Massachusetts Department of Environmental Protection
Bureau of Resource Protection - Wetlands
WPA Form 5 – Order of Conditions
 Massachusetts Wetlands Protection Act M.G.L. c. 131, §40

1. From: Amesbury
 Conservation Commission

5. Project Location:
Summit Avenue and Route 150 Amesbury
 a. Street Address b. City/Town

BSC Group, Inc. (BSC) is pleased to submit this wetland resources peer review report on the proposed Village at Bailey's Pond (Route 150 and Summit Avenue) Notice of Intent (NOI). Oak Consulting Group (OCG) and Hughes Environmental Consulting (HEC) have submitted revised NOI materials on behalf of Fafard Real Estate and Development Corporation.

C-003B

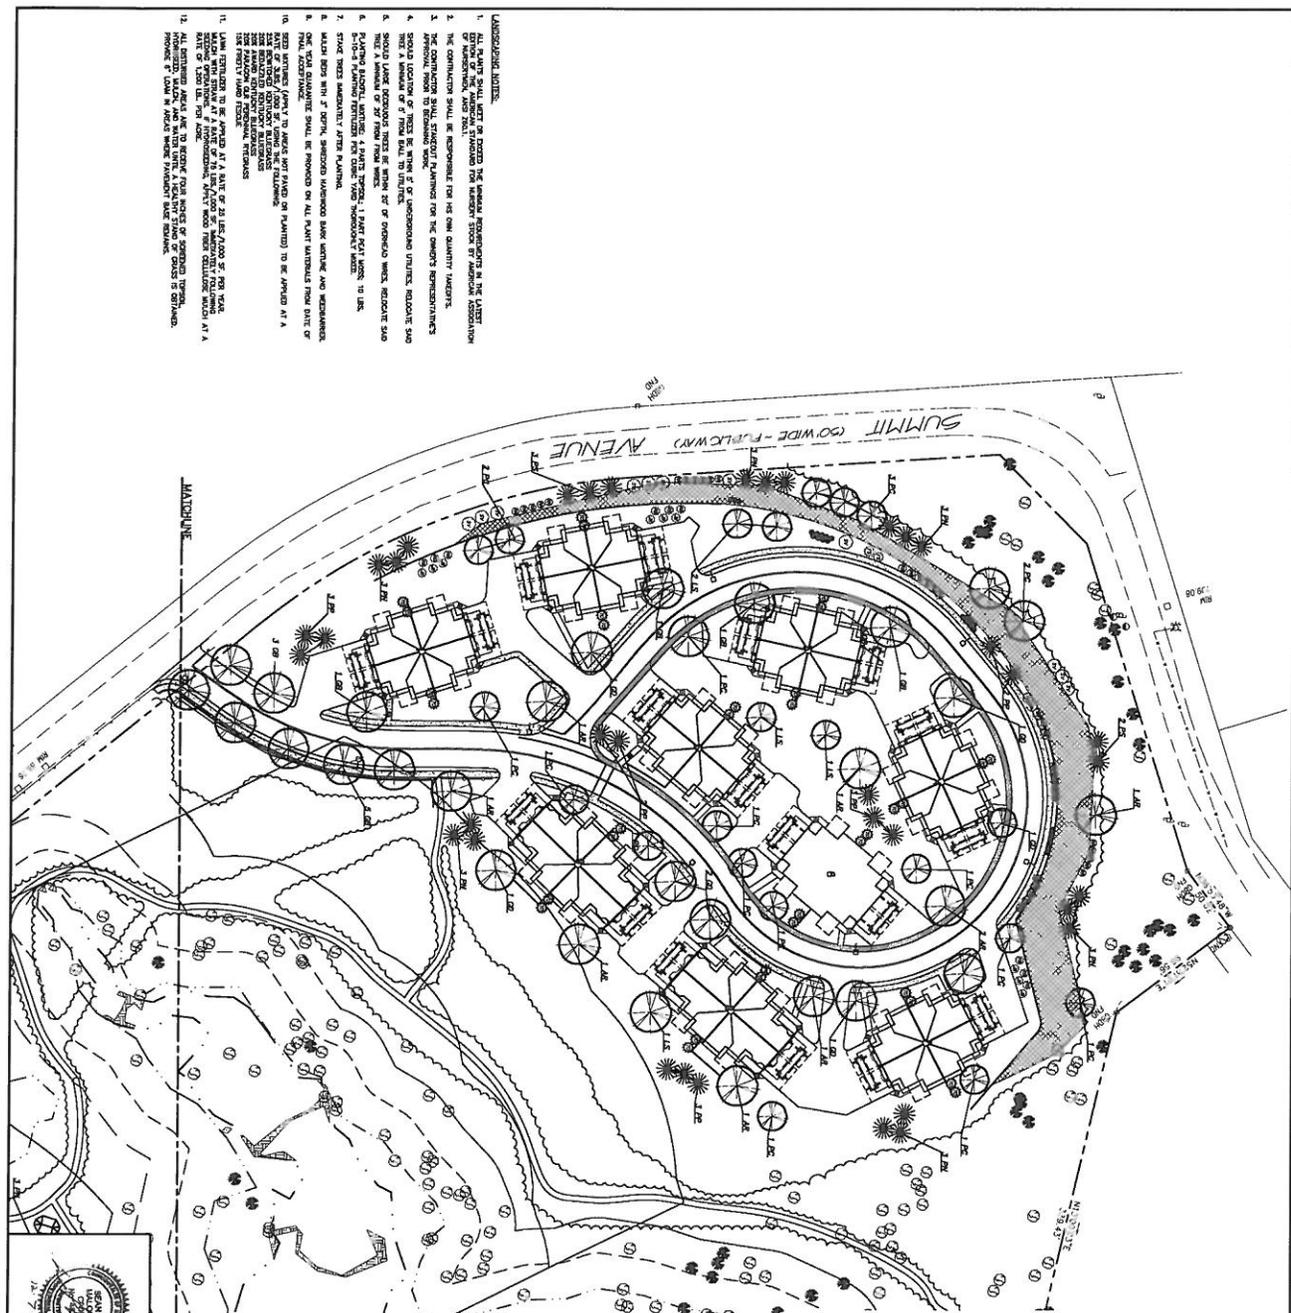
1. Where are the outlets from Bioretention Areas #1 and 3 (Drawings C-003A and C-003B respectively)? It appears that these overflow onto a parking lot and the site driveway. Can an overflow structure for each of these BMP’s be provided per the detail on Drawing C-009 and piped into the closed stormwater management system?

3. The rip-rap apron southwest of Building 9 (Drawing C-003A) is drawn with a length of 18 to 20-feet, but labeled at 12-feet long. Based on the slope shown, the drawn length of 18 to 20-feet seems more appropriate.

4. The Applicant's designer should verify that the rip-rap apron at the 30-inch discharge southwest of Building 9 (Drawing C-003A) is sufficiently sized for the potential flows.

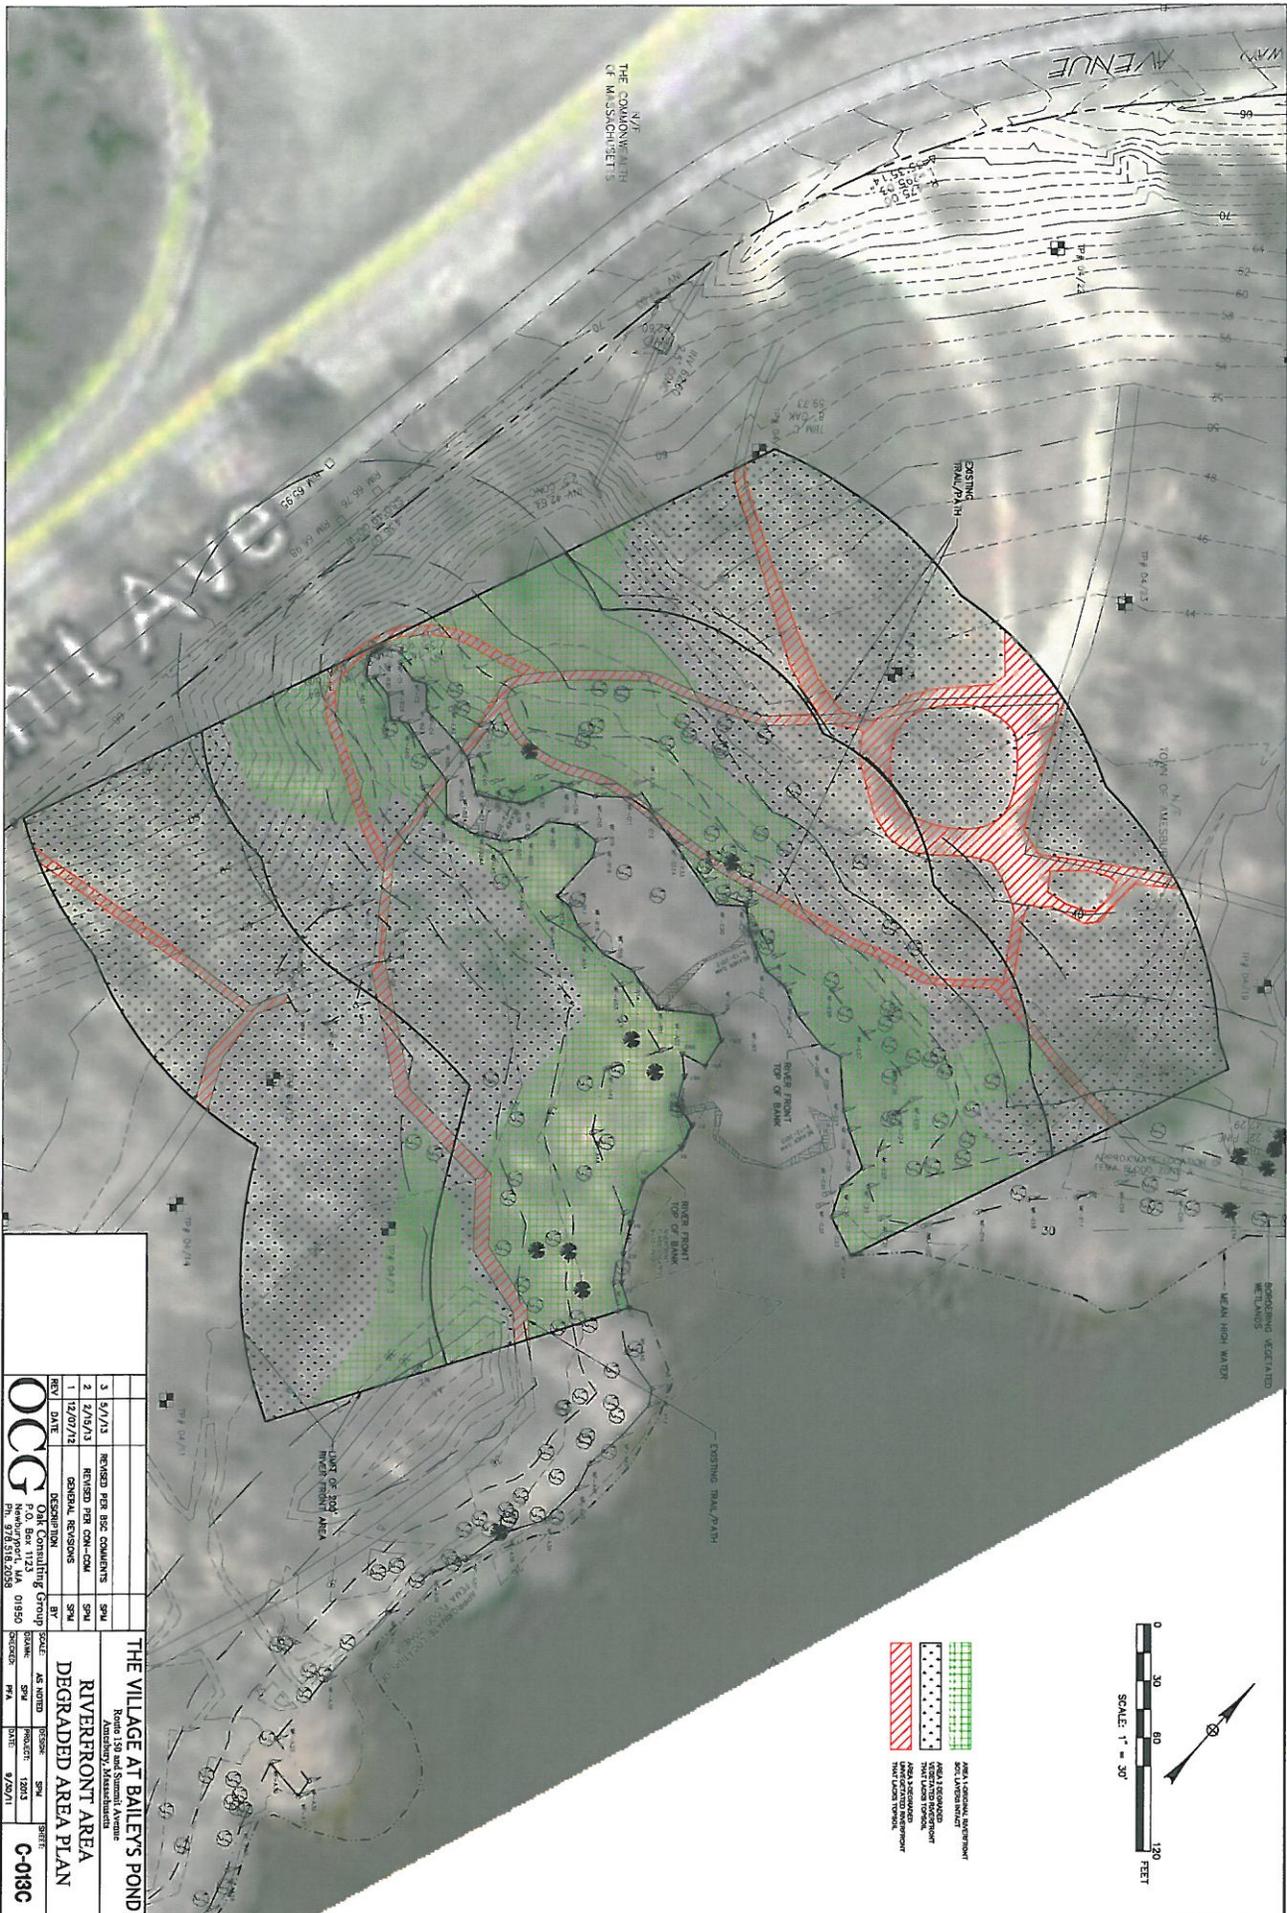
Area 3 - This area, shown on plan sheet C-13C in red, is an area stripped of topsoil and void of any vegetation since active mining of the site prior to 1996. That this area is degraded cannot be genuinely debated. This area covers more than 15,000 square feet of the riverfront area (a larger percentage of the RA than was present in the Ipswich matter referenced above). As discussed above, BSC's view appears to be that this area is not degraded because it is not functioning in a manner similar to pavement. That view is based on a misunderstanding of the regulations. As discussed above, "absence of topsoil" is sufficient to render an area degraded. In the Decision and Order on Motions to Strike and for Directed Decision, In the Matter of Edward T. McLaughlin, Trustee, ETM Realty Trust, the Magistrate addressed this issue...

- 4) Thomas G. Hughes, Hughes Environmental Consulting. May 1, 2013. Response to Peer Review Comments, Village at Bailey's Pond, Amesbury, Massachusetts with accompanying site plan titled Riverfront Area Degraded Area Plan C-013C dated September 30, 2011 with third revision dated May 1, 2013.
